MOONEY AIRCRAFT, INC.

M-18 SERVICE LETTER NO.17

DATE: OCTOBER 24, 1959  
SUBJECT: REAR BULKHEAD REINFORCEMENT  
MODELS AFFECTED: NOTED  
TIME OF COMPLIANCE: IN CONJUNCTION WITH MOONEY M-18 SERVICE LETTER NO. 16

FIG. 2

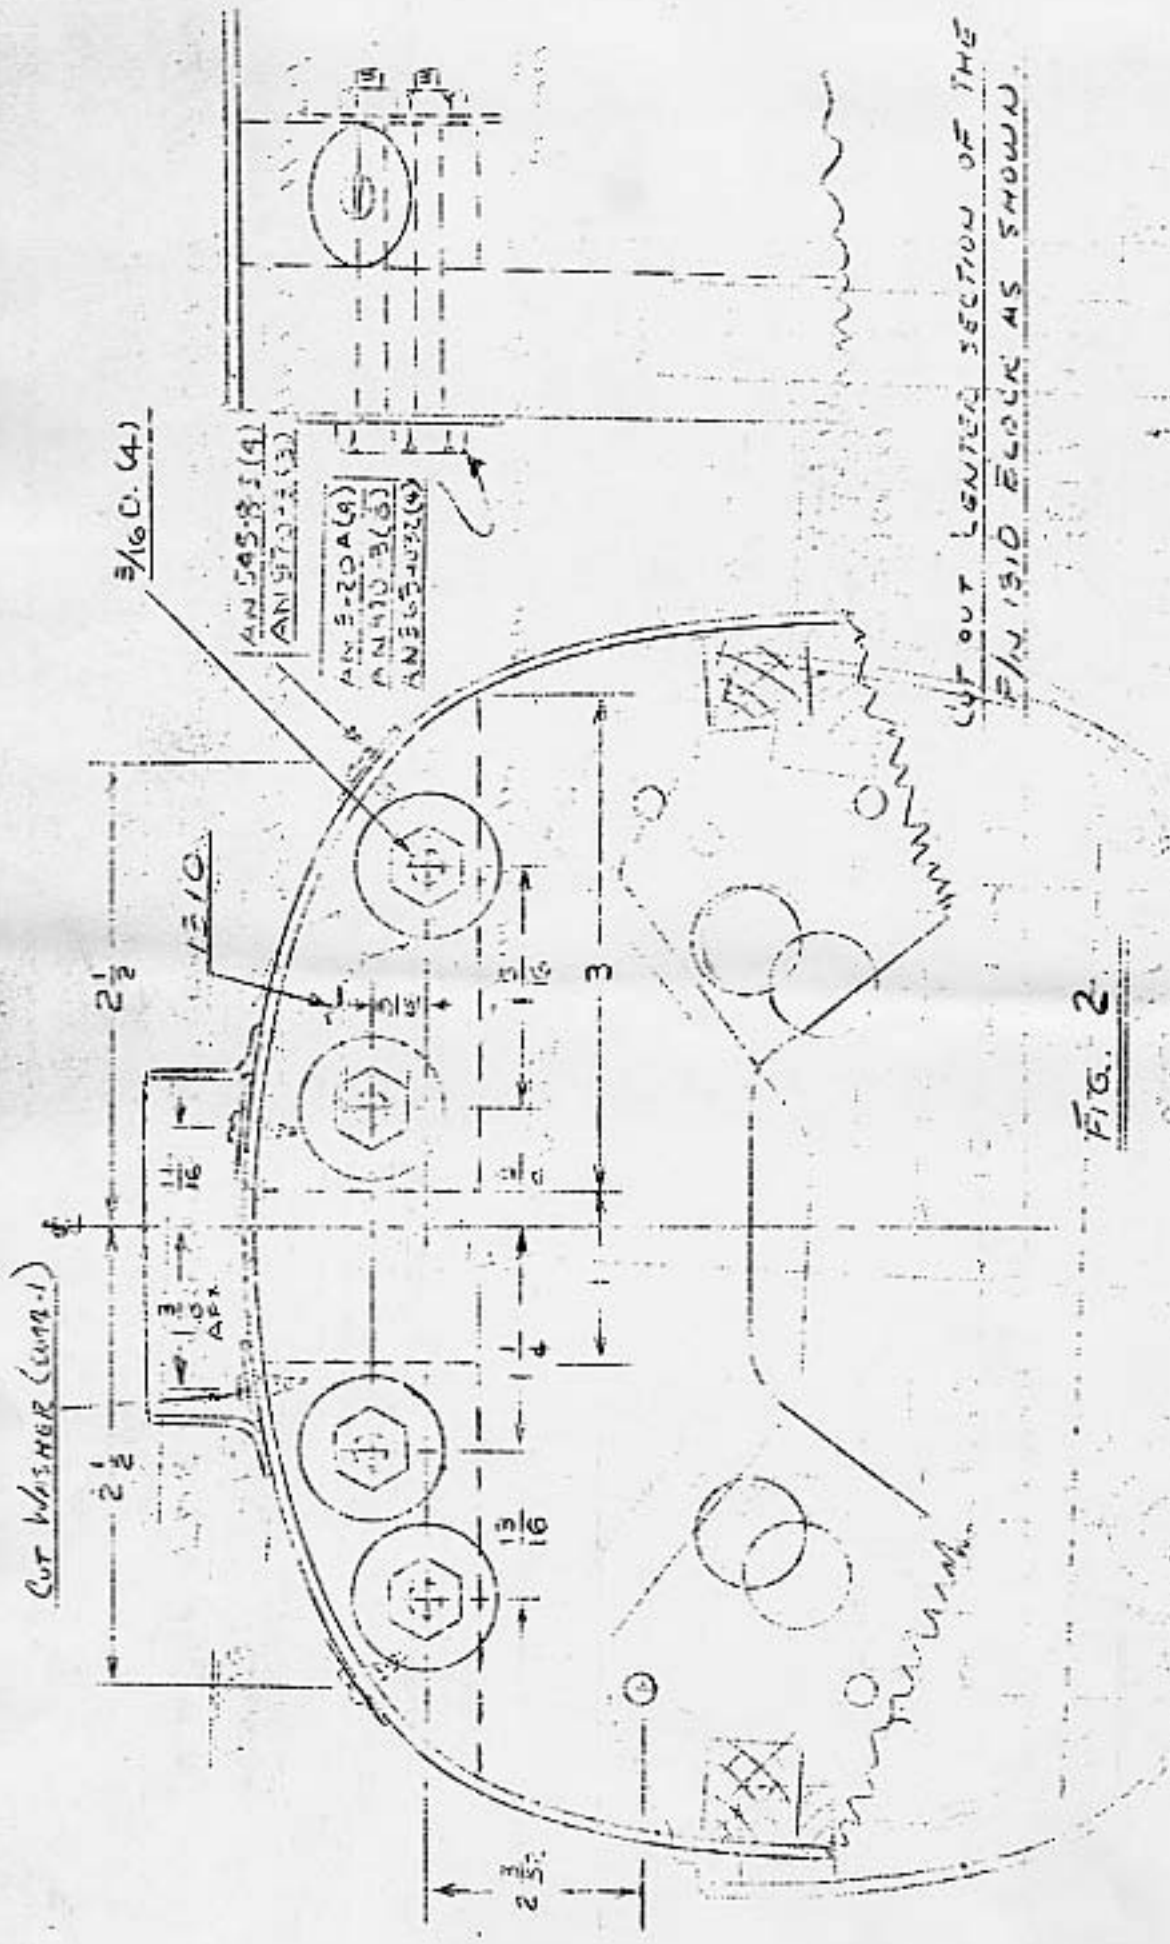
1. All airplanes having the defect described in Item 1 of the Introduction are to be repaired in accordance with Figure 1 or Figure 2 depending on the type of elevator control system.
2. Order Rework Kit SL 18-17-1.

NOTE. THIS DRAWING IS FOR M-18 MODELS EQUIPPED WITH THE PUSH-PULL ELEVATOR CONTROL SYSTEM.

CUT OUT LOWER SECTION OF THE FINISHED BLOCK AS SHOWN.

Fig. 3

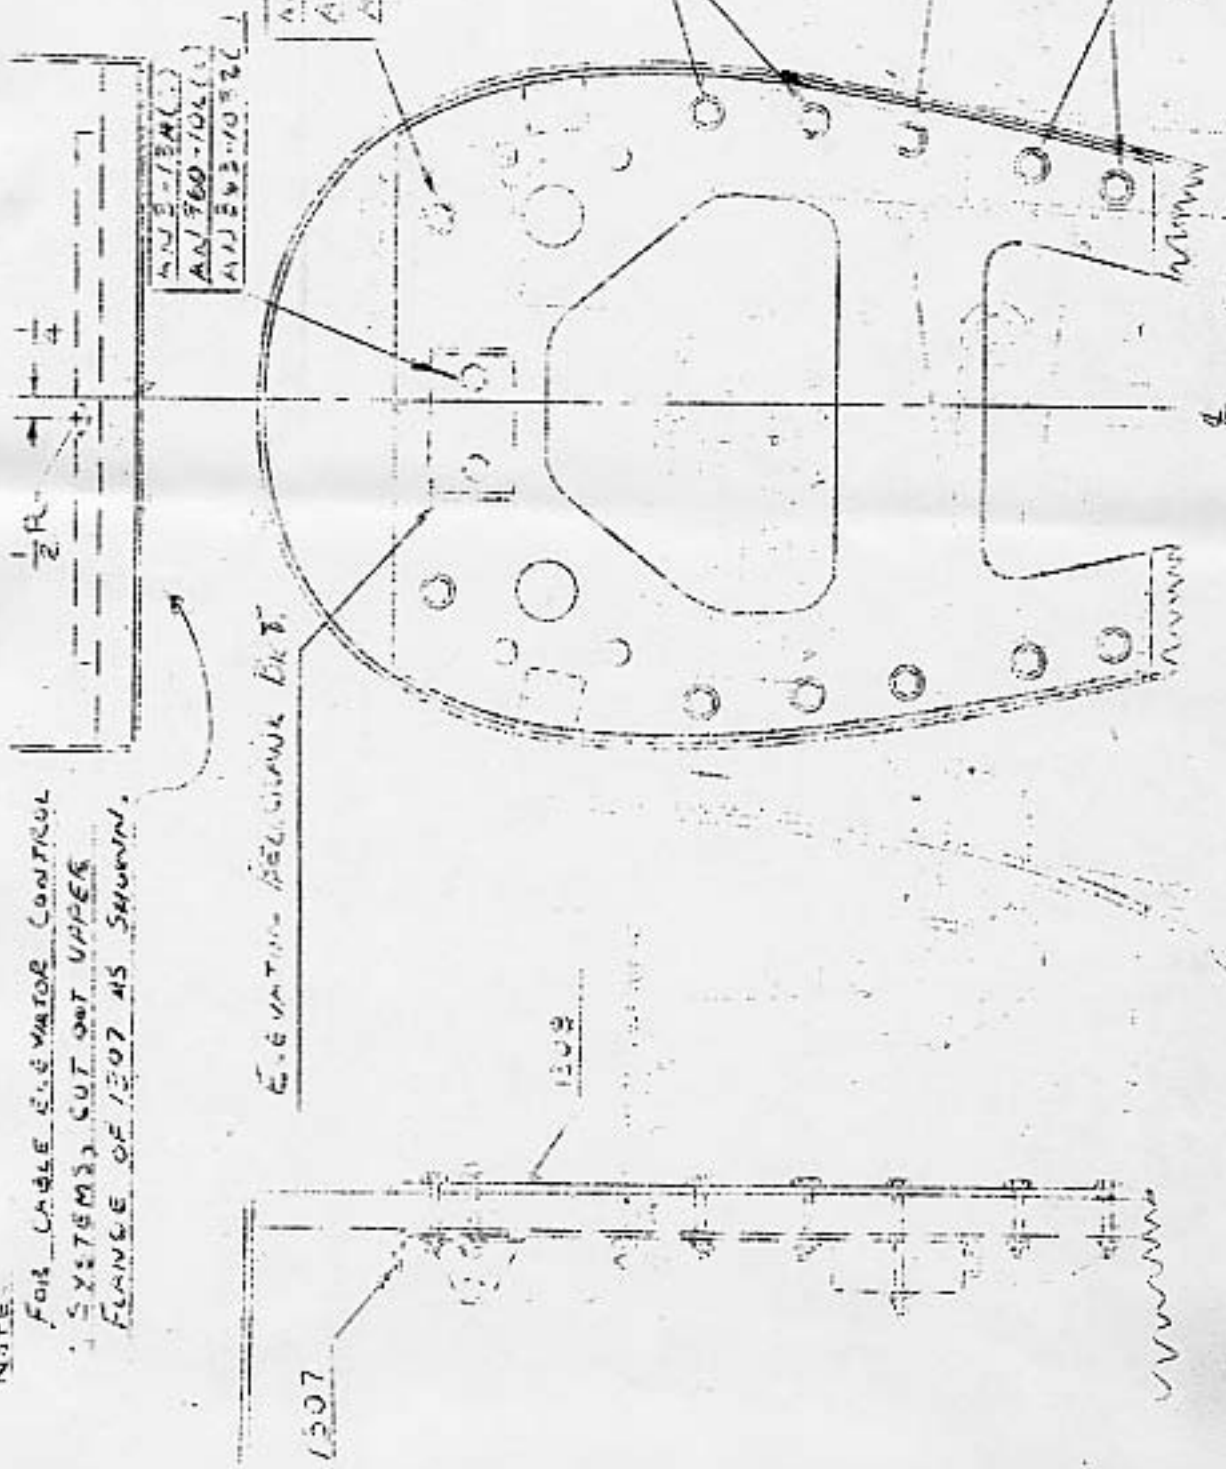
- a. Remove the following items from bulkhead:
  - i. Elevator bellcrank bracket
  - ii. Lead ballast weight if installed
  - iii. Longeron clips P/N 1157-1/-2 (if installed) by removing bolt through upper longeron
- b. Clean excess paint or glue off faces of bulkhead so that plates bear on flat surface.
- c. Attach P/N 1307 and 1308 plates to bulkhead using AN3 bolts through the tail attachment holes, elevator bellcrank bracket and holes, and lead ballast and holes. NOTICE - Do not reassemble tail attachment brackets at this stage.
- d. Using P/N 1308 as template drill 3/16 diameter holes (10) through bulkhead and P/N 1307. Exercise care to drill holes perpendicular to bulkhead. Install AN3 bolts specified in Figure 3 for attachment of elevator bellcrank bracket, lead ballast, and through holes drilled. Exercise care in tightening bolts so as not to crush bulkhead.

THIS DRAWING IS FOR M-18 MODELS EQUIPPED WITH THE CABLE ELEVATOR CONTROL SYSTEM.

FOR CABLE ELEVATOR CONTROL SYSTEMS, CUT OUT UPPER FLANGE OF 1307 AS SHOWN.

FIG. 4

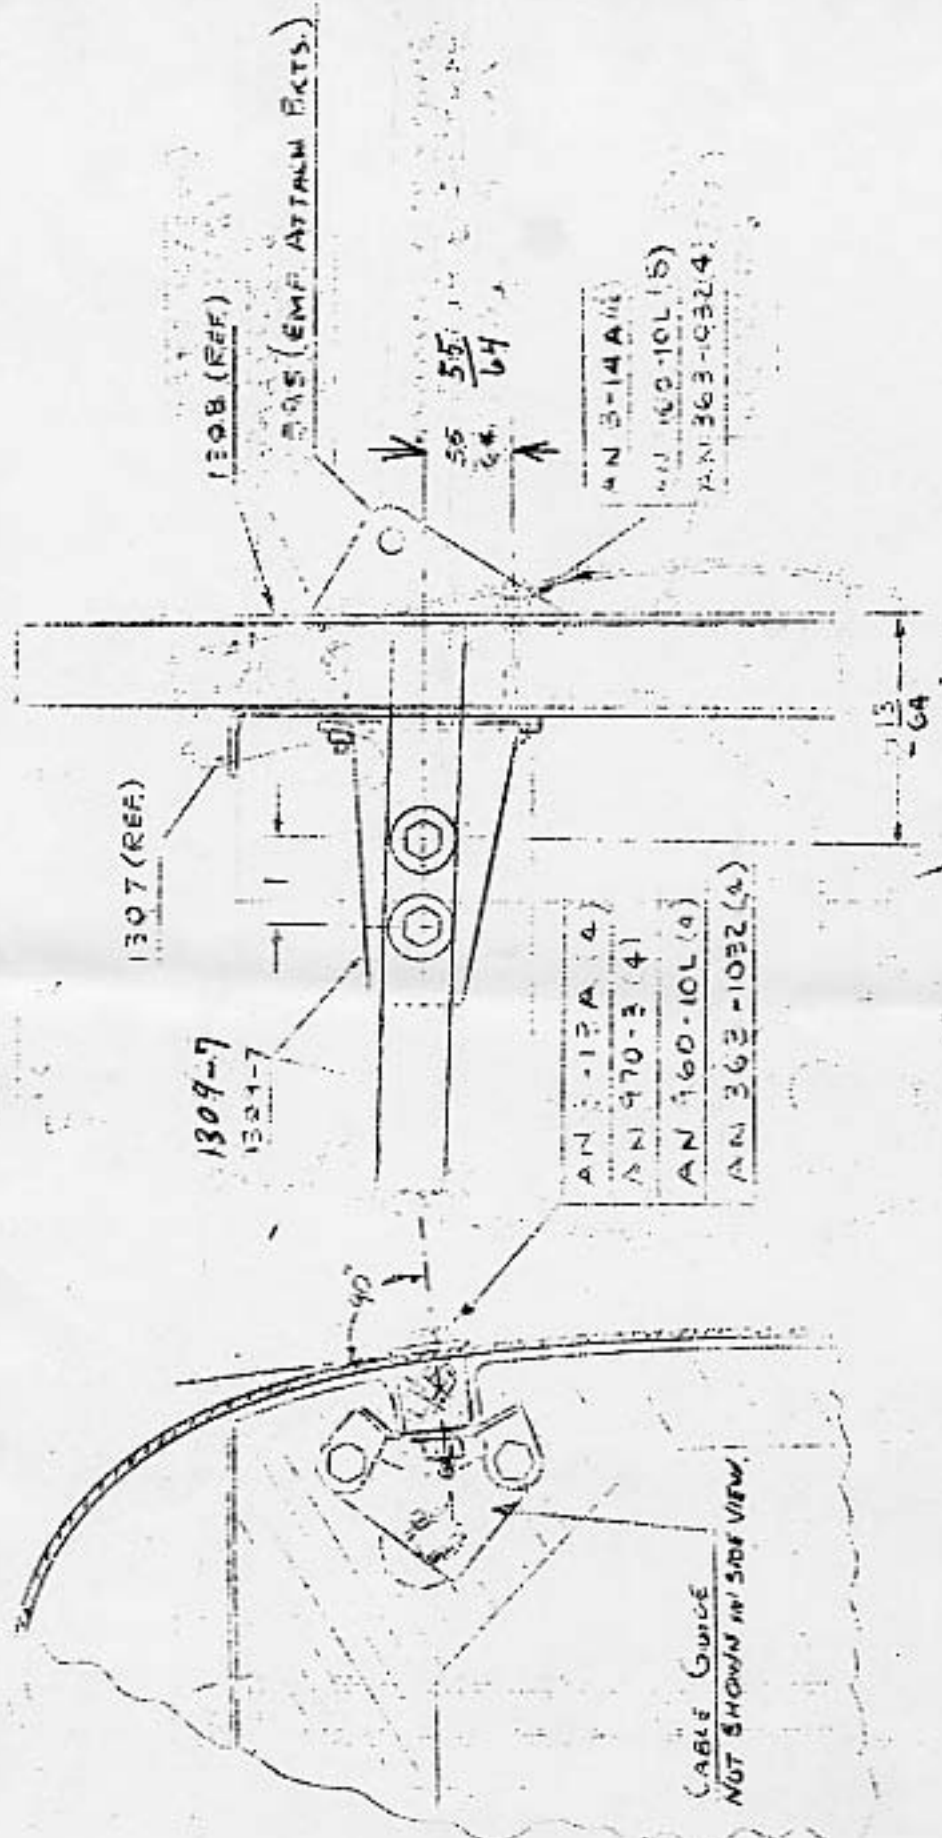
1. For all airplanes not having P/N 1151-1/-2 clips installed, the following must be accomplished after compliance with Part B:
  - a. Mark the location on the outside of tail cone of the four holes through the upper longeron as shown on Figure 4.

- b. Drill one of the holes on each side with a 1/16 diameter drill perpendicular to skin. Examine the inner face of the longerons. The holes should be in the center of the longeron. If the hole is off-center, correct the error as much as the original hole will allow by re-drilling the other two holes with a 1/8 diameter drill. Applying the same correction, drill the other two holes with a 1/8 diameter drill.

- c. Install P/N 1309-7/-8 fittings, empennage attachment brackets and cable guides as shown in Figure 4.
  - d. Block fittings to prevent play and, using 1/8 diameter holes as guides, drill 11/64 diameter holes (4) through longerons and 1309 fittings. Using 11/64 diameter holes as guides, drill out holes to 3/16 diameter.

- e. Bolt the 1309-7/-8 fittings to the longerons as shown in Figure 4. Exercise care in tightening bolts so as not to crush wood.

FIG 5

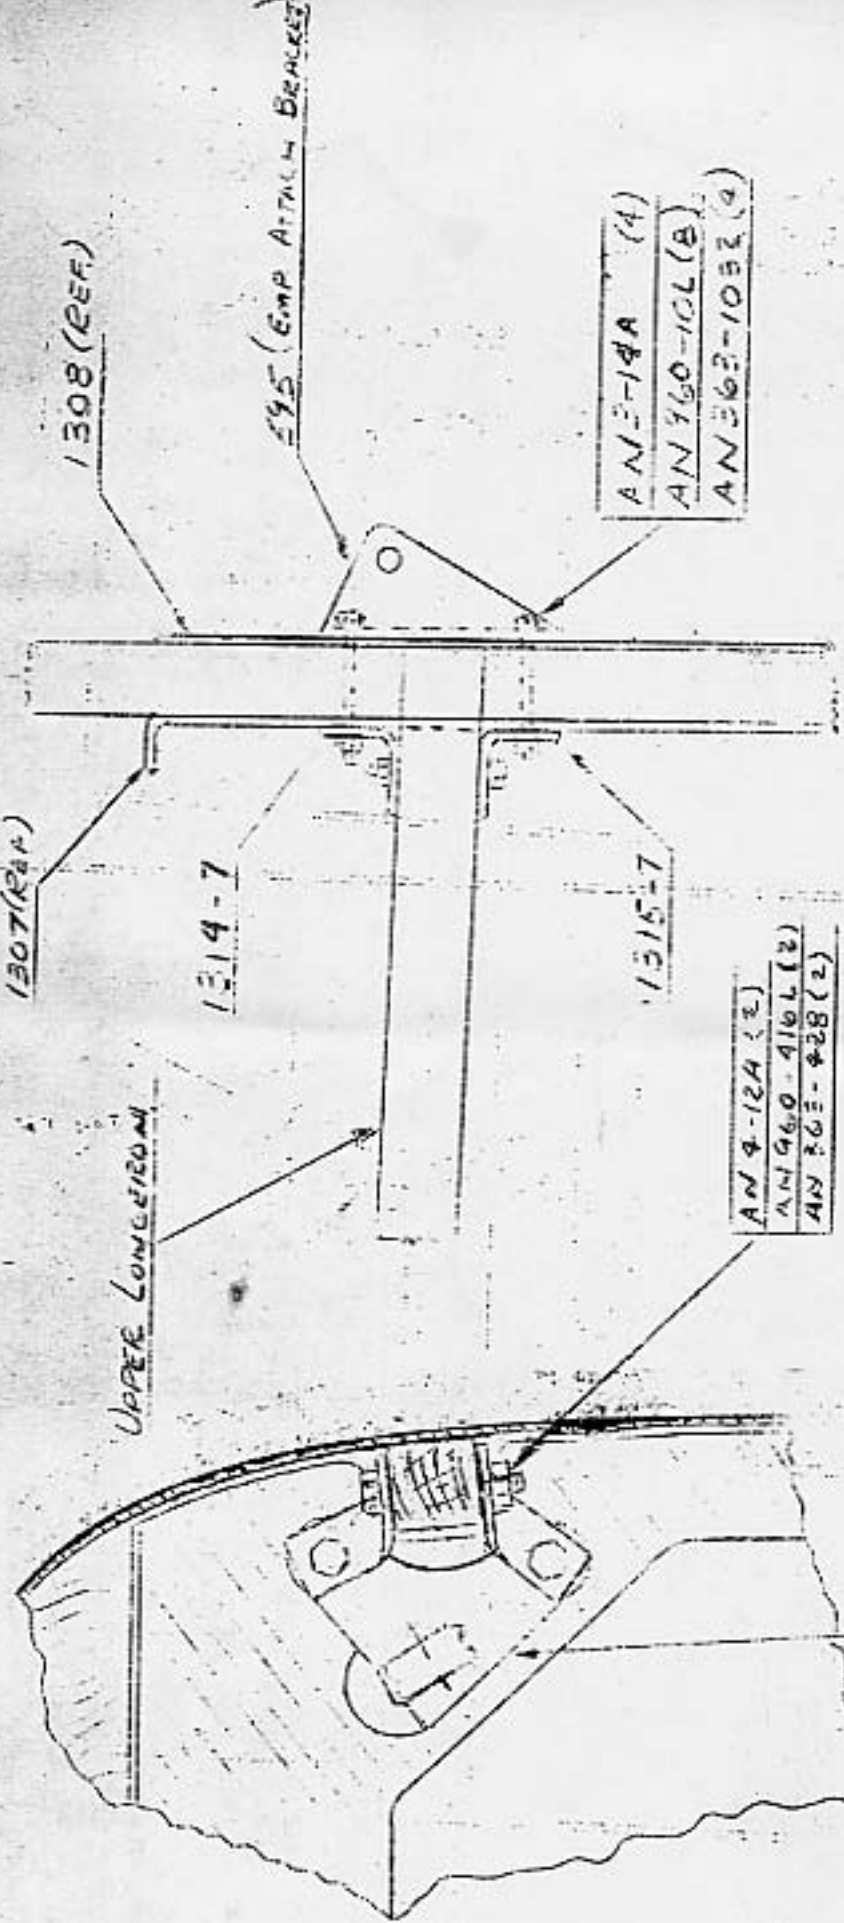
1. For airplanes which had P/N 1157-1/-2 clips installed and which have been reworked in accordance with Part B, the following shall be accomplished:
  - a. Reinstall empennage attachment brackets and cable guides and replace P/N 1157-1/-2 clips with P/N 1314-7/-8 clips and add P/N 1315-7/-8 clips on lower side of upper longeron picking up lower bolt of empennage attachment brackets as shown in Figure 5. Install vertical bolt through two clips and longeron as shown.
2. Order Kit No. SL 18-17-3.
